Central Planning Authority

Minutes of a meeting of the Central Planning Authority held on October 13, 2021 at 10:00am, in Conference Room 1038, 1st Floor, Government Administration Building, Elgin Avenue.

CPA/21/21

Figure 1: DOE’s 2013 Habitat Map Extract showing application site (outlined in blue)

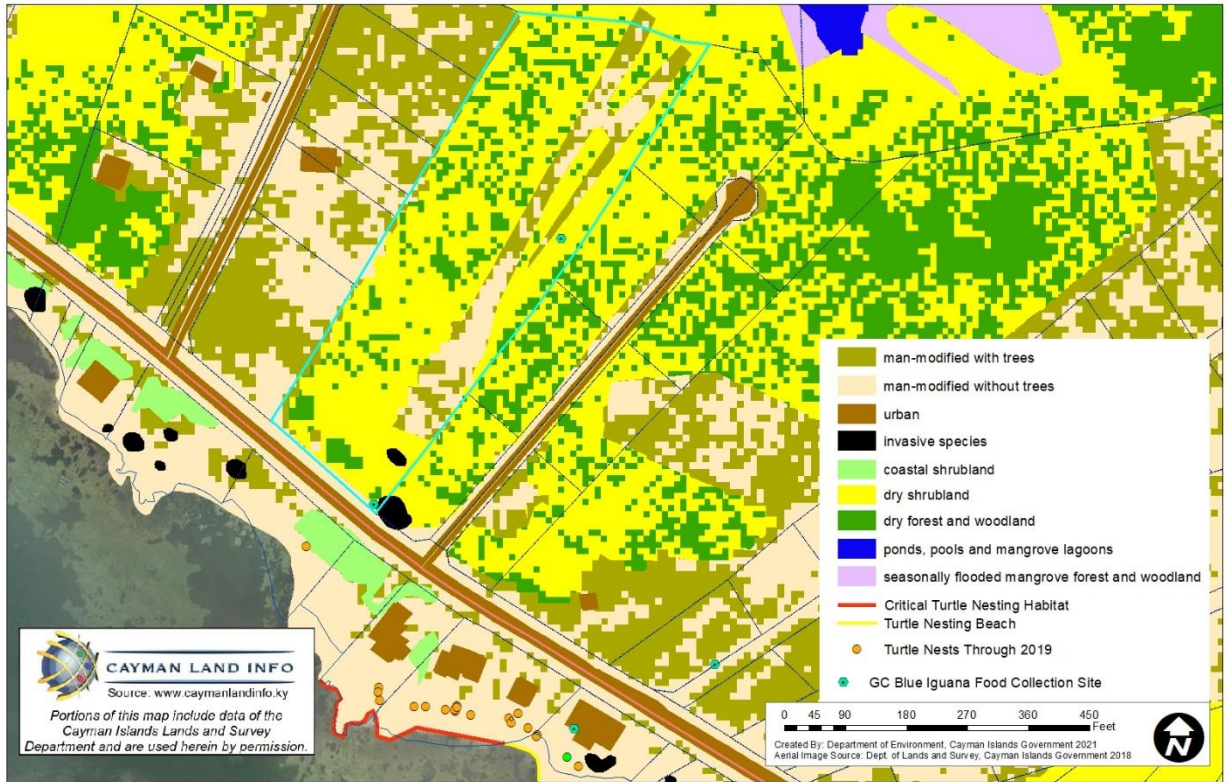
*The application site consists primarily of dry shrubland and forest with some limited areas that have been man-modified (See Figure 1), but has regrown with valuable secondary growth as shown in Figure 2. There are two locations on the parcel where food for the Blue Iguana Recovery Programme is collected by Blue Iguana Conservation staff (formerly Blue Iguana Recovery Programme). In addition, the site is located to the north-west an area designated as critical habitat for nesting sea turtles as defined in the Interim Directive for Green turtles, (*Chelonia mydas*), Loggerhead turtles (*Caretta caretta*), Hawksbill turtles (*Eretmochelys imbricata*) and all other species that may occur in Cayman Waters.*

- *Retain native vegetation where possible and incorporate it into the landscaping scheme as native vegetation is best suited to the site conditions and is a cost effective option.*
- *A vegetated buffer strip should be left between the development access road and the eastern boundary to allow for the retention of Blue Iguana Recovery Programme food collection sites on the parcel. This vegetated buffer would also provide some privacy between the development and the adjacent parcels*
- *The natural ridge on site should remain as is. There shall be no excavation or mining of the ridge.*
- *The applicant should not include any floodlights or spotlights which are directed towards the turtle nesting beach.*

Figure 3: Plan Extract Overlaid onto LIS 2018 Aerial Imagery showing location of Iguana Food Collection sites (Blue Dots) (Plan source: Jay Welcome March 2021; Aerial Imagery, Lands and Survey Department, 2018)

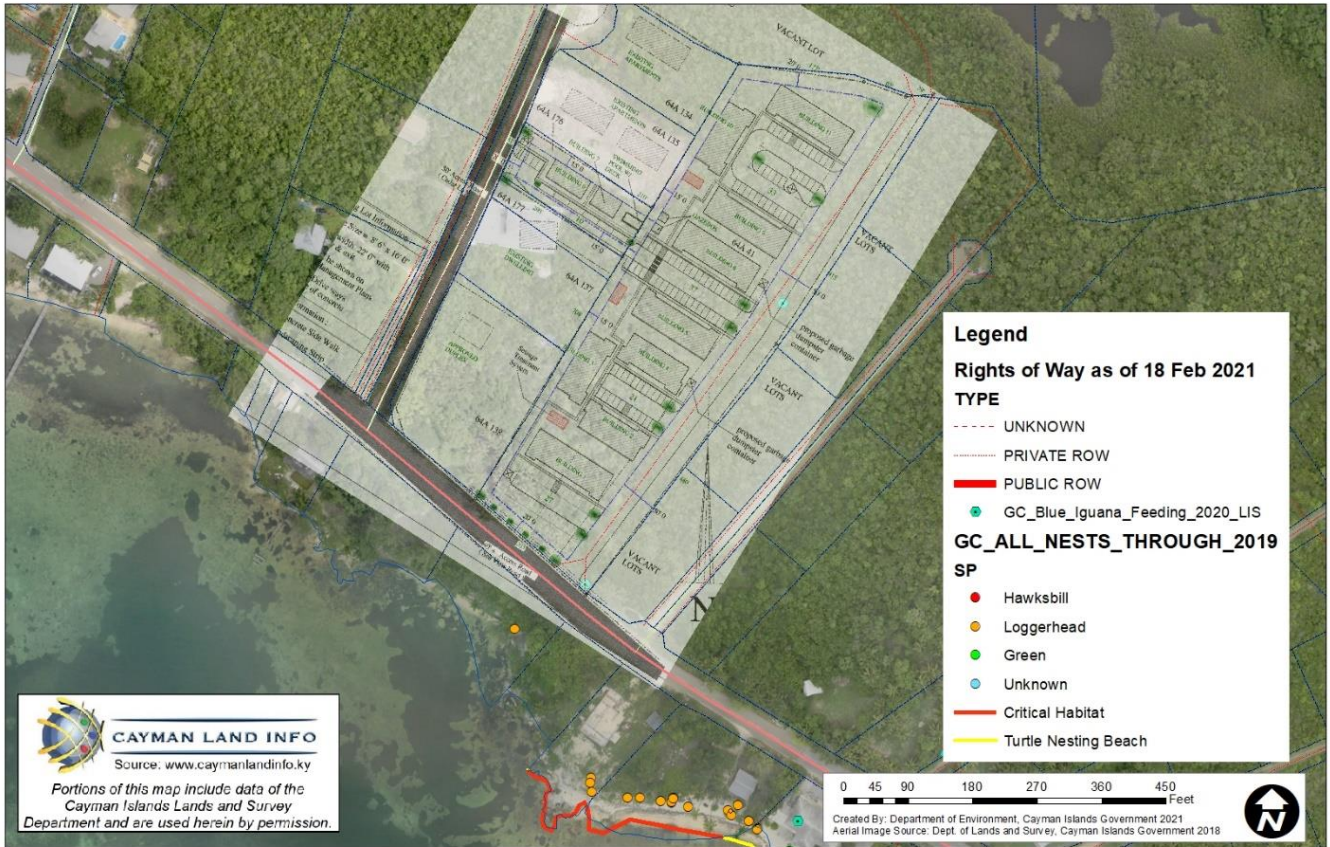
The application site has two locations where Blue Iguana food is collected. These collections spots are on the eastern boundary and east of the proposed development access road as shown in Figure 3. The DoE recommends that the vegetation along the road is retained to allow for the food collection sites to remain. This strip could also act a vegetated buffer between the development and the adjacent parcels.

*Figure 4: Showing LIS Terrain Model of the application site's (outlined in blue) ridge
(Source:Lands and Survey Department)*

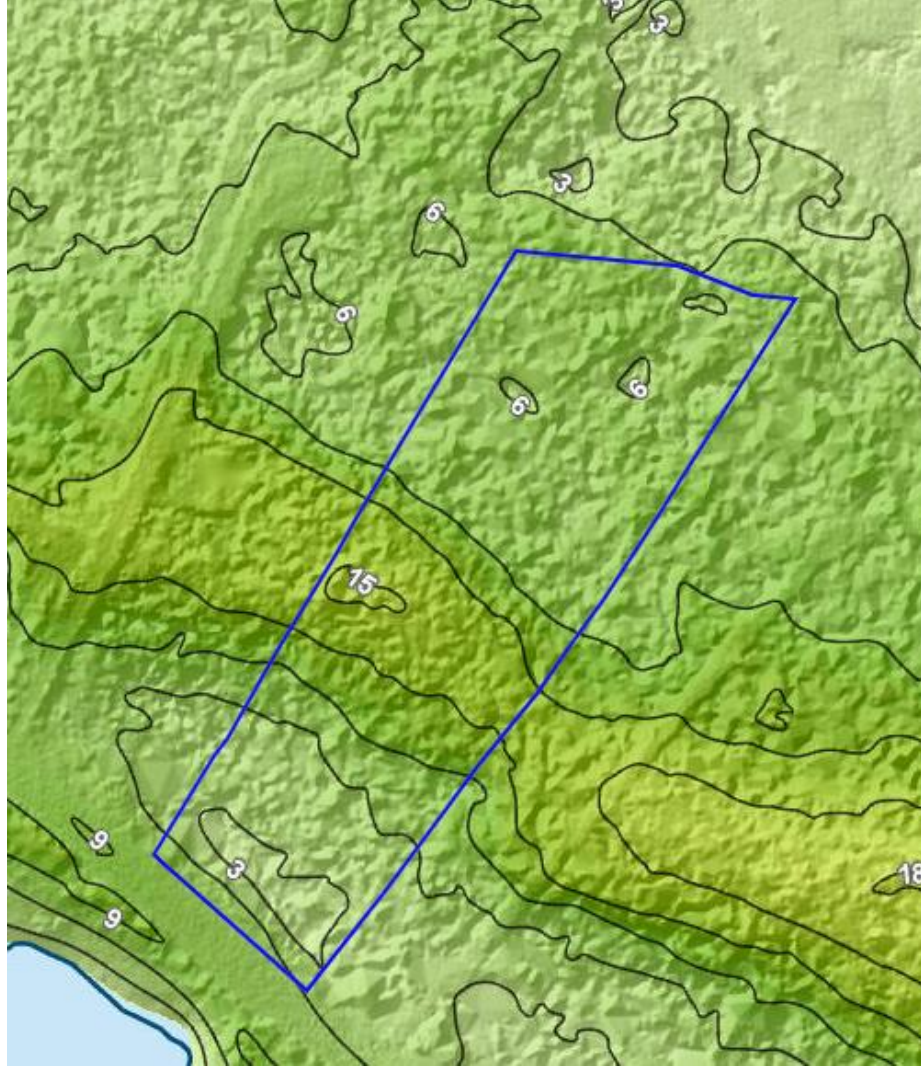
The terrain model as provided by the Lands and Survey Department (see Figure 4 and 5), indicates that there is a ridge in the center of the parcel that goes up to approximately 15 feet above mean sea level. The Department does not support any excavation or mining of the ridge. This geological feature of the site should remain and to be incorporated into the design of the development. It will assist with the resilience of the development to the impacts of climate change, including storm surge.

Figure 1. The habitat present at the site (outlined in light blue), indicating mangroves along the southern boundary.

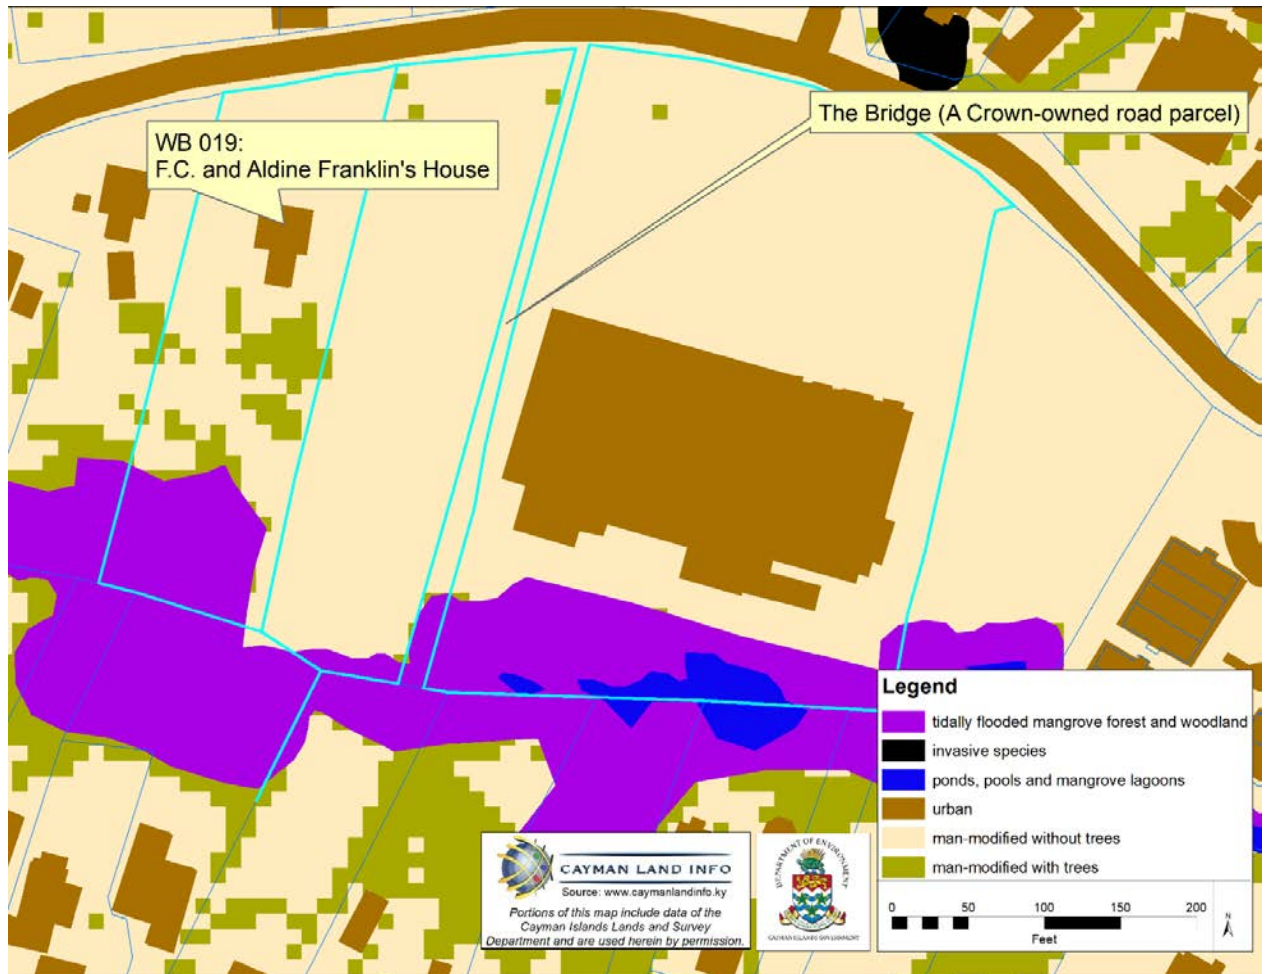
There is primary habitat along the southern boundary of the site, which is seasonally flooded mangrove forest (see Figure 1). Mangroves are a Schedule 1 Part 2 Protected Species under the National Conservation Act 2013 and there is an adopted Mangrove Conservation Plan (2020).

We recommend the retention of mangroves where possible. We note that the Applicant is proposing to keep the mangroves behind the existing supermarket, but is proposing to clear, fill and use the area of mangroves to the west, however the purpose is not outlined on the map – it may be recycling or storage. It is recommended that this area be retained as mangroves, which can also assist with drainage. As shown in Figures 5 to 8, the area with the existing mangroves is low-lying and is likely providing stormwater drainage for the area.

- The plans be modified to preserve the mangroves in the southwestern corner of the site,*
- The plans are revised to retain F.C. and Aldine Franklin's house in situ,*
- Further research into the boardwalk and trail is conducted by the National Trust, and*
- The plans are revised to protect or conserve the Bridge as agreed pending further discussion.*

Figure 8. The Bridge is still visible as recently as the 2004 aerial imagery. In the 2008 Aerial imagery, the Bridge has been demolished as part of the previous expansion of the Foster's supermarket.

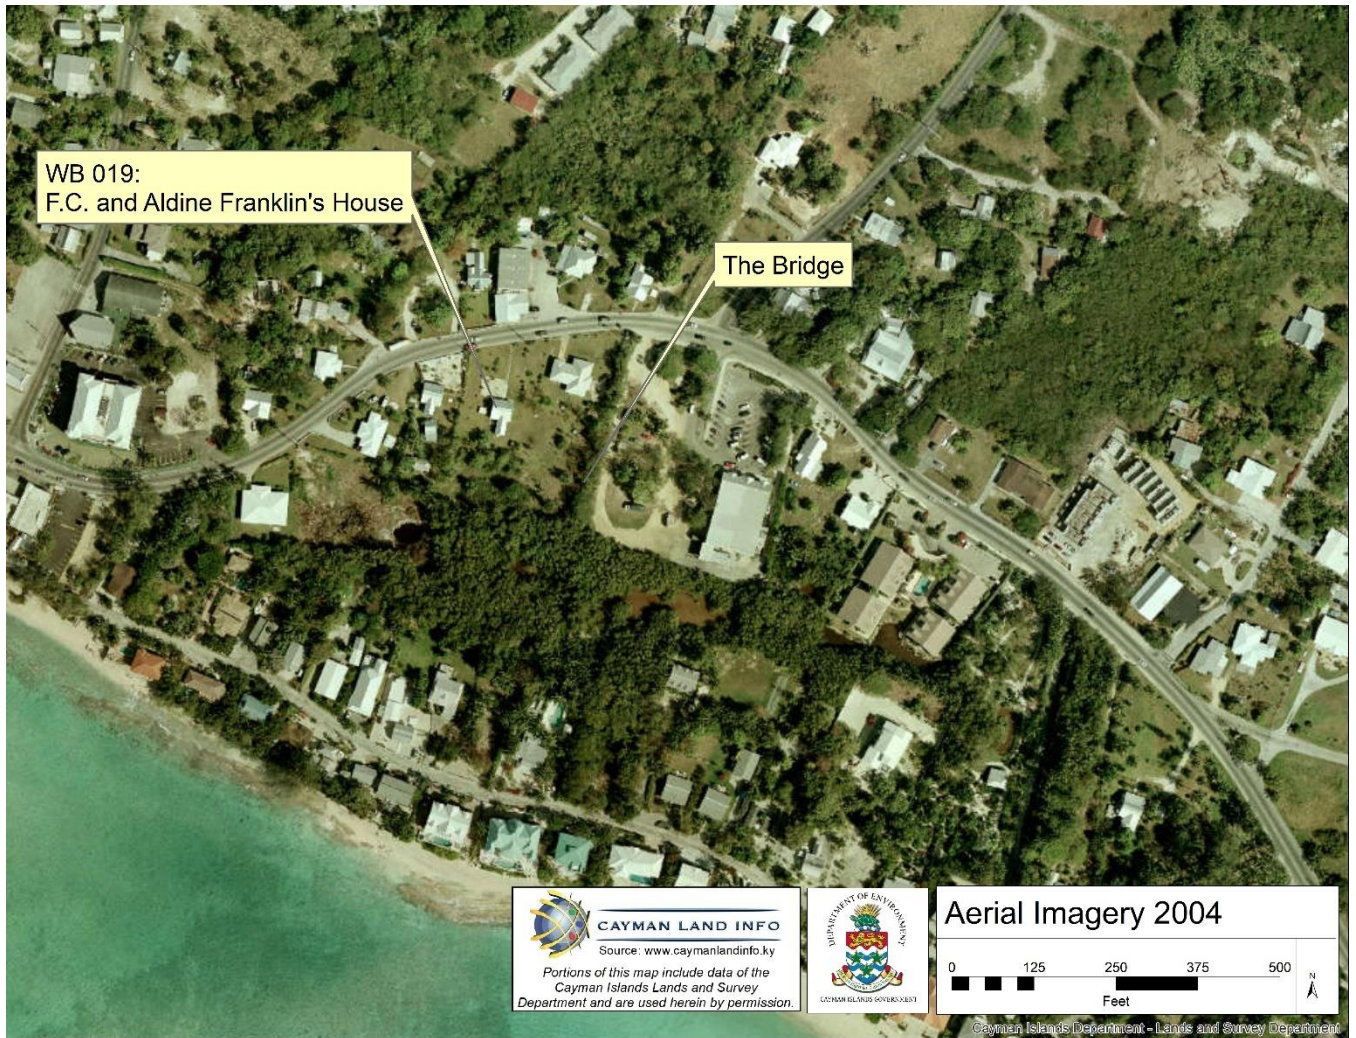
In 2013, the Bridge is no longer visible, and is now part of the parking lot and a grassy area for the Foster's supermarket, even though the parcel is still registered as a public road. The expansion proposed would place the buildings of the supermarket over the public road. Currently, very little evidence of the Bridge is present (see Figure 9).

Figure 1: DOE's 2013 Habitat Map Extract showing Application Parcel Outlined in Blue
 Retaining vegetation can provide benefits to the property owner and the surrounding area, including:

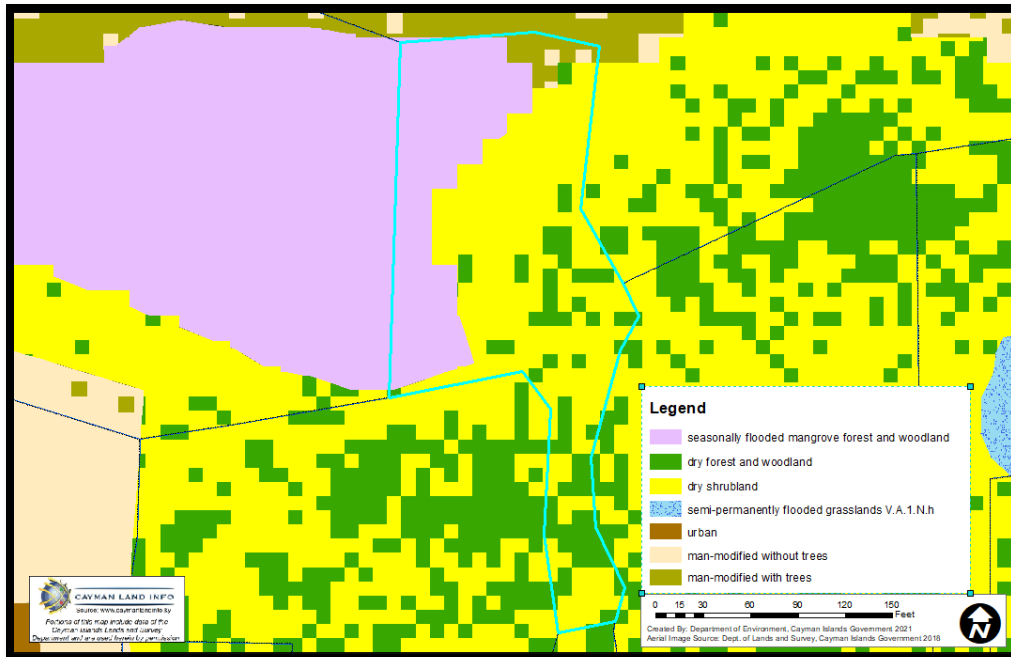
The Applicant proposes to clear primary habitat, namely dry shrubland, dry forest and seasonally flooded mangrove forest and woodland. There is no justification provided from the applicant, and there is no development proposed to justify the loss of primary habitat. Clearing this site in the absence of an approved development or use, is considered to be speculative clearing which is not a practice that the DoE supports. Speculative land clearing removes the option of retaining native vegetation outside the footprint of a prospective development. It also results in the fragmentation of undisturbed primary habitat in the surrounding area. It is important to note that fragmentation is continuing to affect primary habitat interrupting important ecological services, wildlife corridors and facilitating the introduction of invasive species on cleared land.

Figure 1. The habitat present at the site.

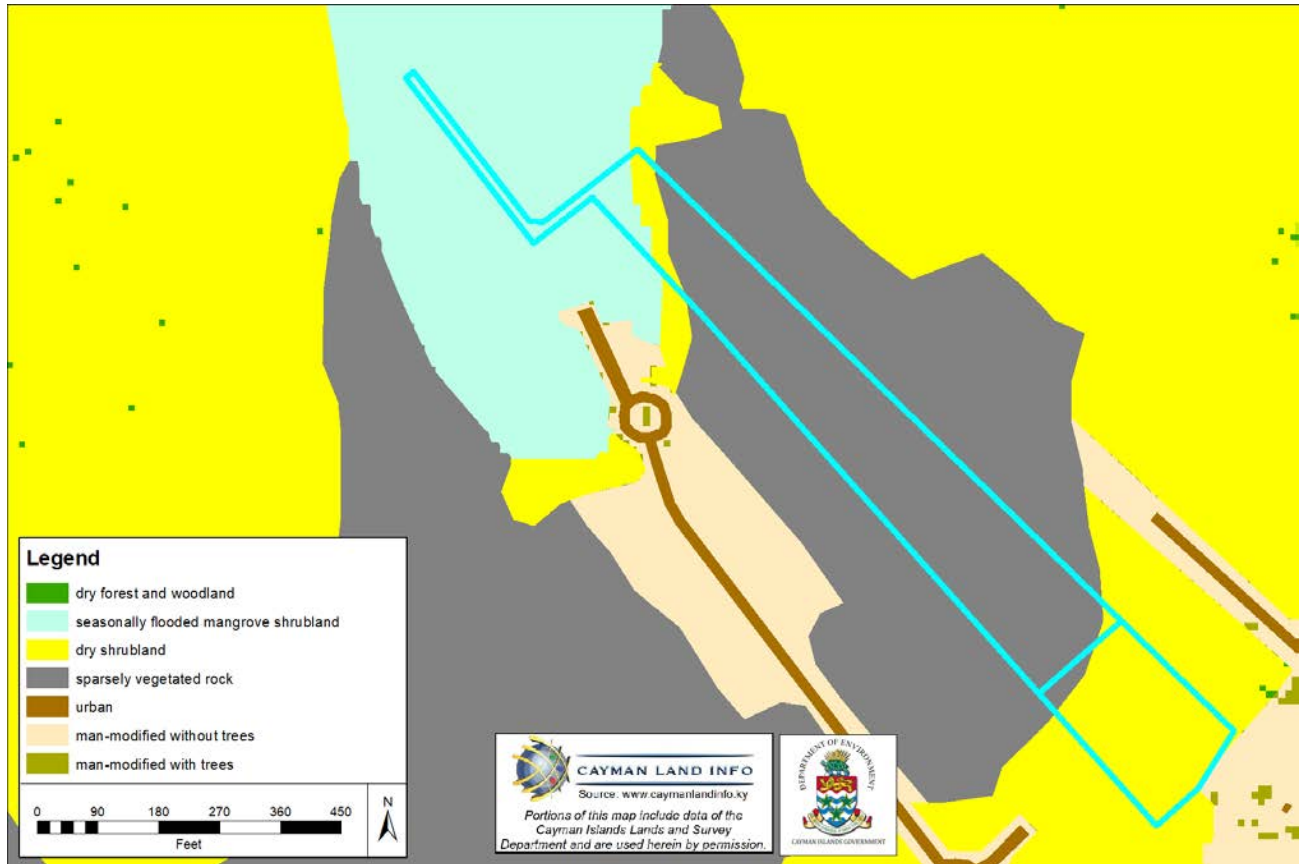
The site is primary habitat, occupied by dry forest and shrubland in the south, sparsely vegetated rock in the central area and some seasonally flooded mangrove shrubland to the north, as shown in Figure 1. The site is very low-lying, lower than the road and development to the south. The low elevation is likely one of the reasons for the lack of vegetation in the central area.

Therefore, if the Central Planning Authority is minded to approve this application, we recommend the following:

Figure 1. The habitat present at the site.

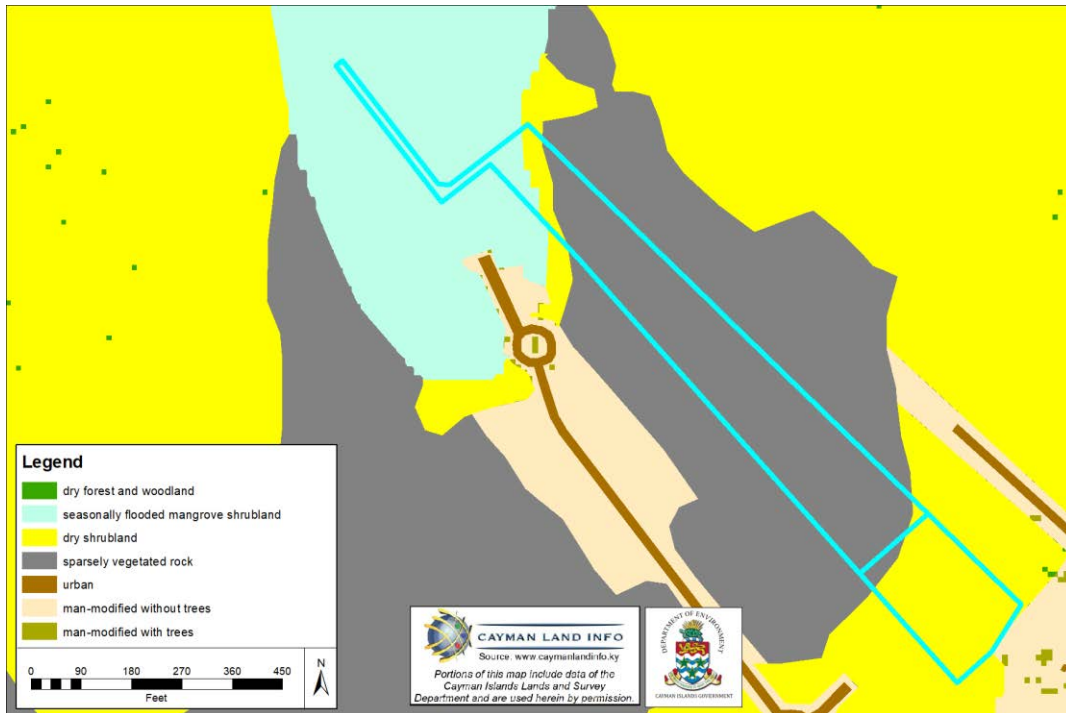
The site is primary habitat, occupied by dry forest and shrubland in the south, sparsely vegetated rock in the central area and some seasonally flooded mangrove shrubland to the north, as shown in Figure 1. The site is very low-lying, lower than the road and development to the south. The low elevation is likely one of the reasons for the lack of vegetation in the central area.

Therefore, if the Central Planning Authority is minded to approve this application, we recommend the following:

Figure 3: DoE drone image from March 2019 showing the anoxic black/grey sediment nearshore.

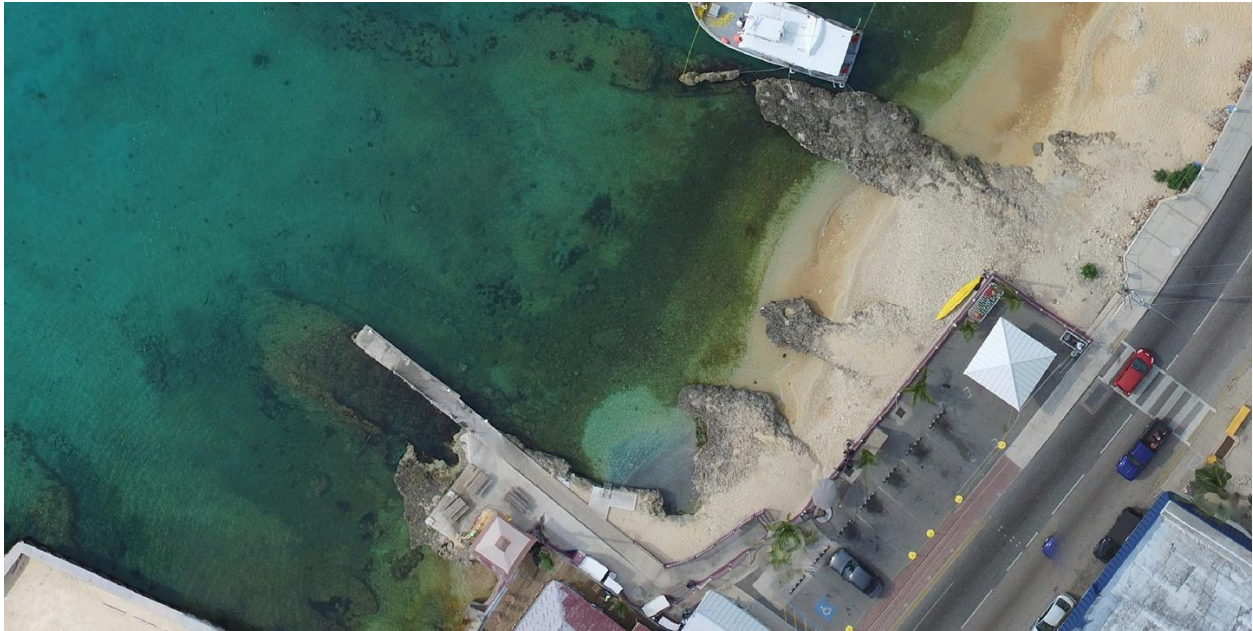
The cumulative effect of the ongoing unauthorised placement of construction sand and other unconsolidated material (including the fill material that is the subject of this application) into and adjoining the marine environment, together with the proximity to the local fish market (where regular fish cleaning results in increased nutrient loading and subsequent marine algal growth in the nearshore environment) is creating negative impacts on water quality. This is evident from the nearshore sediments and beach in the area which are often black or grey in colour with a strong odour exhibiting the anoxic characteristics of a highly disturbed environment (see Figures 3 & 4).
